## PRODUCT CHANGE NOTIFICATION (PCN)

<b>PCN#</b>	WPC-210422-001	<b>Issuing Date</b>	April 22 <sup>th</sup> , 2021
-------------	----------------	---------------------	-------------------------------

Product Name	Description	Supplying Schedule
WizFi630S	PCB layout update to improve product quality.	May 2021

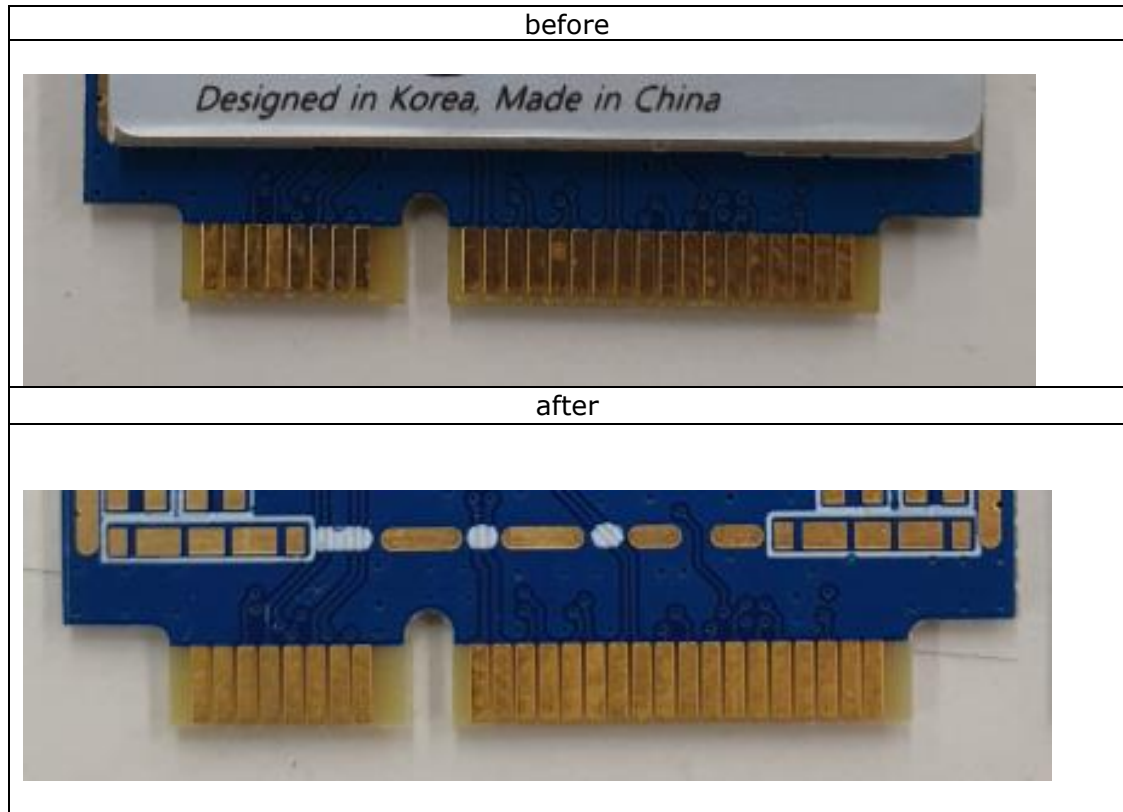
- Reduce gap between connector pad and edge of PCB to 0.25mm or less.
- Mount and fix the shield can in the center of the PCB.

- **Reduce gap between connector pad and edge of pcb to 0.25mm or less.**

- Change connector edge shape from round to float.
- Place the connector pad closer to the edge.

- **Mount and fix the shield can in the center of the PCB.**

- Before shield was soldered to PCB only in 4 points, causing some problems
- Mount and fix the shield with soldered clip in the red highlighted position.
